*This presentation addresses some comments that were submitted as individual comment, per the rule one comment per issue, however they are related since they touch the same STATES and exit conditions and their solution need to be integrated for completeness and easy and clear instructions for the editor if these comments will be accepted.*

## ***PART A: Comments i-250, i-251(Page 136 Line 20)***

## PART B: Comment i-254 (Page 136 Line 11).

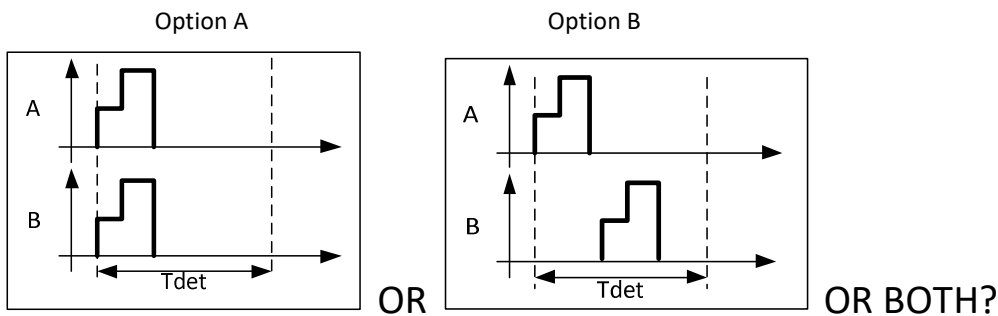
Based on the description in page 109 lines 37-38 for CC\_DET\_SEQ and specifically, CC\_DET\_SEQ=3 for dual-signature means:

Connection check is followed by staggered detection

The first issue is that "parallel detection" and "staggered detection" are not clearly defined in D3.0, however we know what we wanted to do per the following presentations and discussions:

In "parallel detection" the intent was to do simultaneous detection on both pairsets in order to check if detection signature is corrupted when single-signature PD is connected. Now, in D3.0, it is not clear if it is " simultaneous detection on both pairsets" or detecting both alternative in one detection cycle (Tdet) or both.

3. Properly defined what is "parallel" detection and what is "staggered" detection in CC\_DET\_SEQ definition on page 109 after line by addition the following text:

"For single-signature PD, parallel detection means that detection on both pairsets are done within Tdet time period.

" For dual-signature PD, parallel detection means that detection on both pairsets are done within the same Tdet time period.

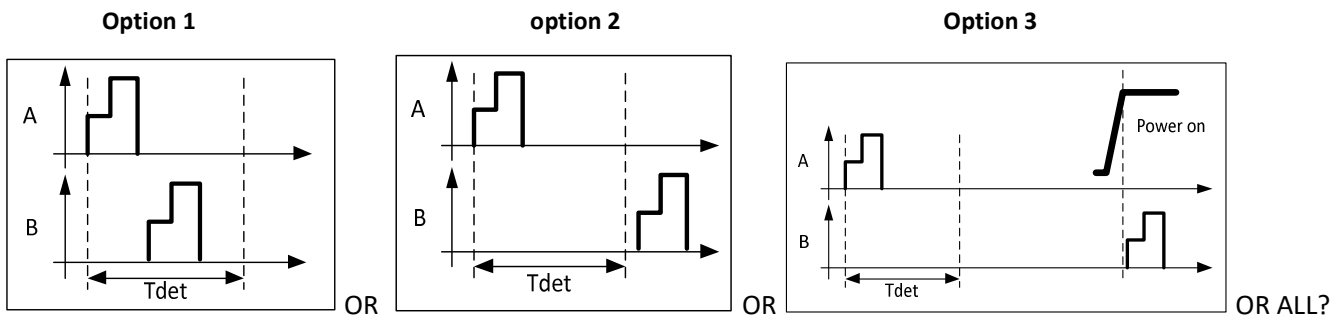
In staggered detection, it should be any non-overlapping detections, with no limits on tdet2ted.

As a result, staggered detection could be any of the following:

The last two options must be covered (2 and 3). The first option (1) depends on what is the definition for "parallel" (See above).

Staggered detection range may occur with starting the secondary detection after doing the primary detection (option 1 and 2) up to doing the secondary detection when the primary is on (option 3). This covers the full range of possibilities for staggered detection.

Option 1 and 2 in CC\_DET\_SEQ=3 is normally used when class\_4PID\_mult\_events\_sec=TRUE. This currently is not covered by the state machine for CC\_DET\_SEQ=3.

Option 3 in CC\_DET\_SEQ=3 is normally used when class\_4PID\_mult\_events\_sec=FALSE and it is covered in the 1st part of the condition:  $(!pwr\_app\_sec * pwr\_app\_pri).$

Option 3 covers ONLY the case that the primary return to IDLE\_PRI due to various reasons and the secondary didn't detect even once: ((CC\_DET\_SEQ=3) \* option\_probe\_alt\_sec \* !det\_start\_pri \* !det\_once\_sec).

"(!pwr\_app\_sec \*pwr\_app\_pri) + ((CC\_DET\_SEQ=3) \* option\_probe\_alt\_sec \* !det\_start\_pri \* !det\_once\_sec) + (class\_4PID\_mult\_events\_sec\*(CC\_DET\_SEQ=3) \* !det\_once\_sec \* det\_once\_pri )

### 3. Make the following changes to the state machine:

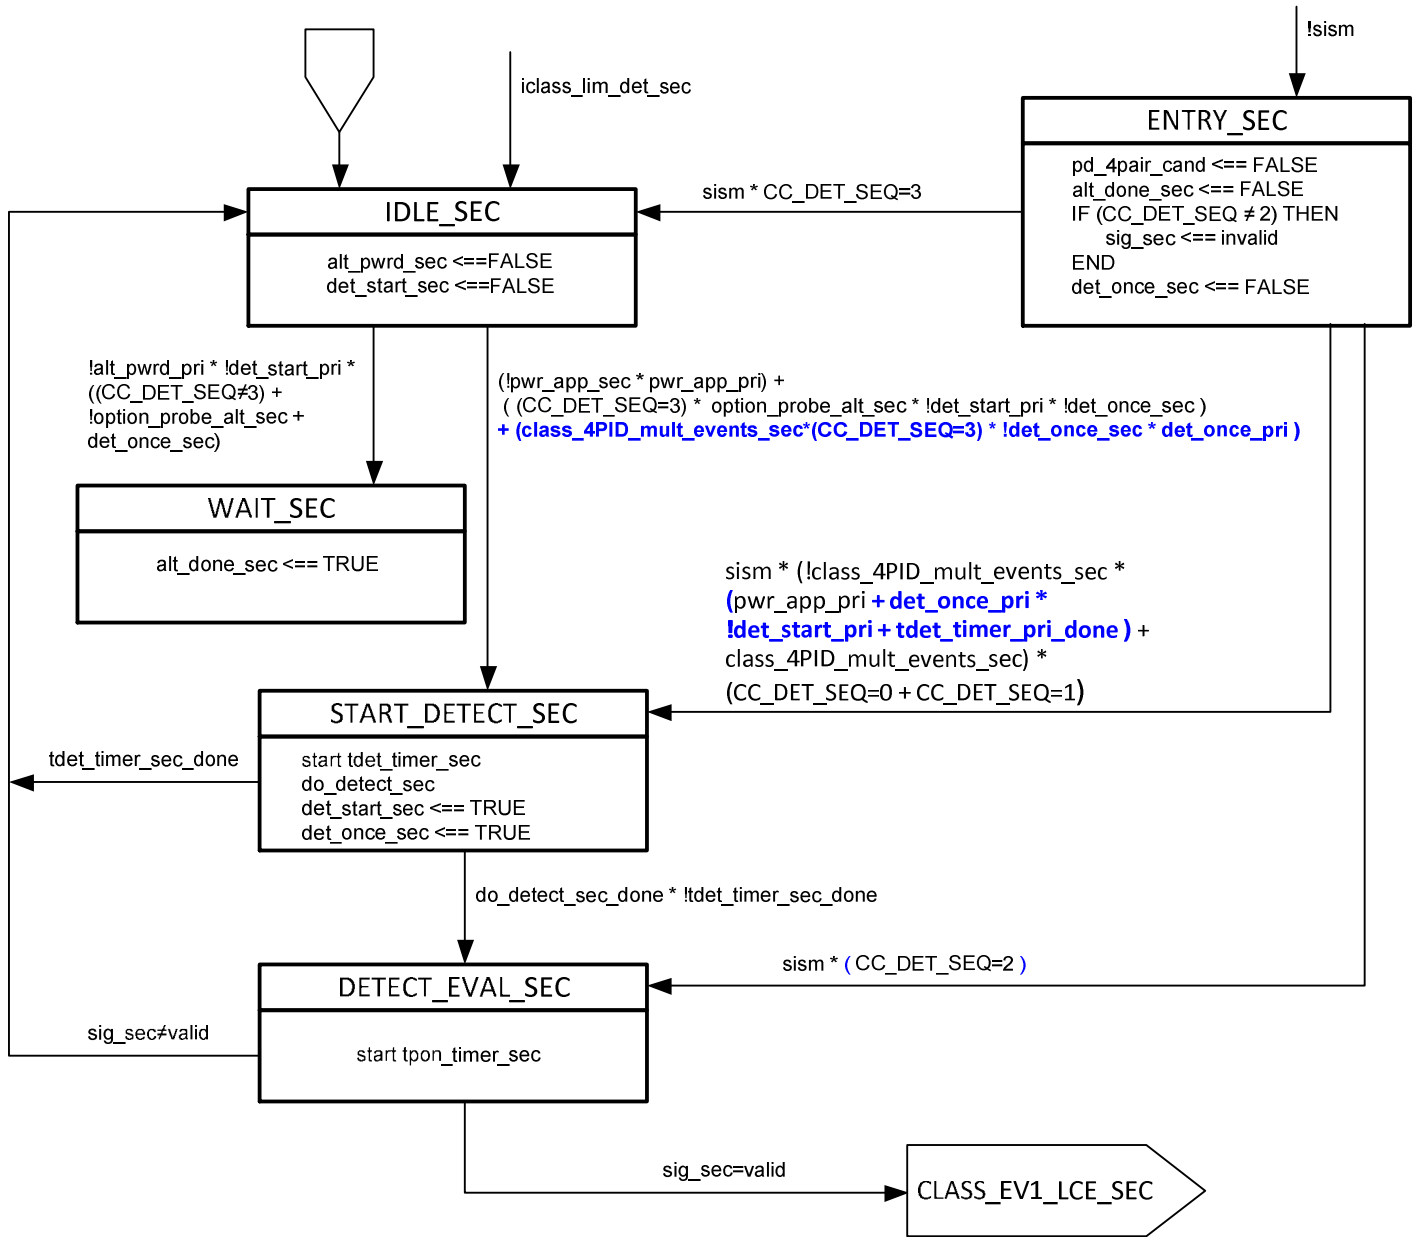
The state diagram should allow staggered detection:

- before Primary power up,
- after primary power up,
- and during power up in case that class\_4PID\_mult\_events\_sec is set to FALSE.

The proposed changes in the state diagram will allow staggered detection after Primary finished its 1st detection without affecting the previous functionality and flow, by OR-ing the additional missing possibility (option 1 and 2).

$\text{sism} * (!\text{class\_4PID\_mult\_events\_sec} * (\text{pwr\_app\_pri} + \text{det\_once\_pri} * !\text{det\_start\_pri} + \text{tdet\_timer\_pri\_done})) + \text{class\_4PID\_mult\_events\_sec} * (\text{CC\_DET\_SEQ}=0 + \text{CC\_DET\_SEQ}=1)$ .

$\text{sism} * ( (!\text{class\_4PID\_mult\_events\_sec} * (\text{pwr\_app\_pri} + \text{det\_once\_pri} * !\text{det\_start\_pri} + \text{tdet\_timer\_pri\_done})) + \text{class\_4PID\_mult\_events\_sec} * (\text{CC\_DET\_SEQ}=0 + \text{CC\_DET\_SEQ}=1) )$ .
